Access Compliance Report

Public Rights-of-Way

(Curb Ramps)

Intersection ID: 10020349	Main Street: BALLANTYNE_COMMONS_PY	Cross Street: N/A	Location: SW
ADA ID: C8E63EA96578	Ramp Type: Perp	Initial Pass/Fail: Fail	Overall Compliance: No
Severity Score: 17.5			
Codes/Mitigation Info/Possible Solution		Field Measurements/Component Compliance

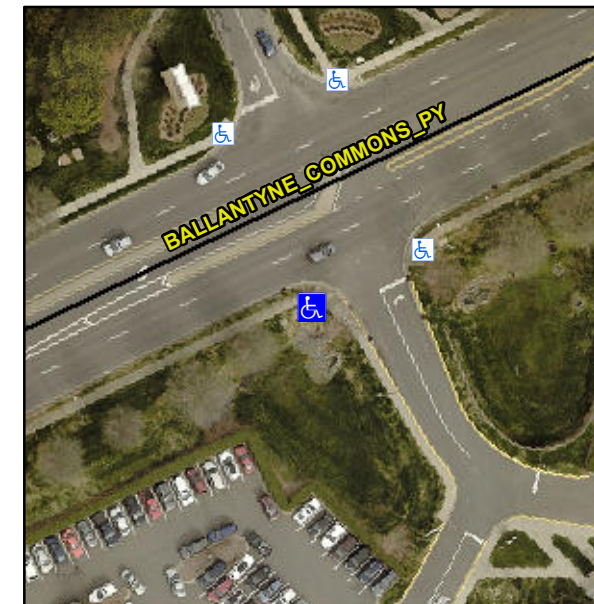
Not Found, R304.5.1

Compliance	Description	Data	Compliance	Description	Data
N/A	Ramp Length (in)	106.0	Yes	Ramp Slope (%)	6.2
No	Ramp Width (in)	32.5	Yes	Ramp XSlope (%)	0.9
N/A	Flare Type LT	N/A	N/A	Flare Type RT	N/A
N/A	Flare Slope LT (%)	N/A	N/A	Flare Slope RT (%)	N/A
N/A	Flare Traversable LT?	N/A	N/A	Flare Traversable RT?	N/A
N/A	Landing Length (in)	N/A	N/A	DWS Provided?	N/A
N/A	Landing Width (in)	N/A	N/A	DWS Contrast?	N/A
N/A	Landing Slope (%)	N/A	N/A	DWS Length (in)	N/A
N/A	Landing X Slope (%)	N/A	N/A	DWS Full Width?	N/A
N/A	Landing Curb? (Y/N)	N/A	N/A	DWS Offset (in)	N/A
N/A	Shared Landing?	N/A			
N/A	Gutter Ponding?	N/A	N/A	Gutter Slope (%)	N/A
N/A	Gutter Lip Ht (in)	N/A	N/A	Gutter X Slope (%)	N/A
N/A	Painted X Walk1?	No	N/A	Painted X Walk2?	N/A
	X Walk 1 Direction	To E		X Walk 2 Direction	N/A
N/A	X Walk 1 Width (in)	N/A	N/A	X Walk 2 Width (in)	N/A
	X Walk 1 Slope (%)	3.2		X Walk 2 Slope (%)	N/A
	X Walk 1 X Slope (%)	2.3		X Walk 2 X Slope (%)	N/A

Remove & Replace Entire Ramp.
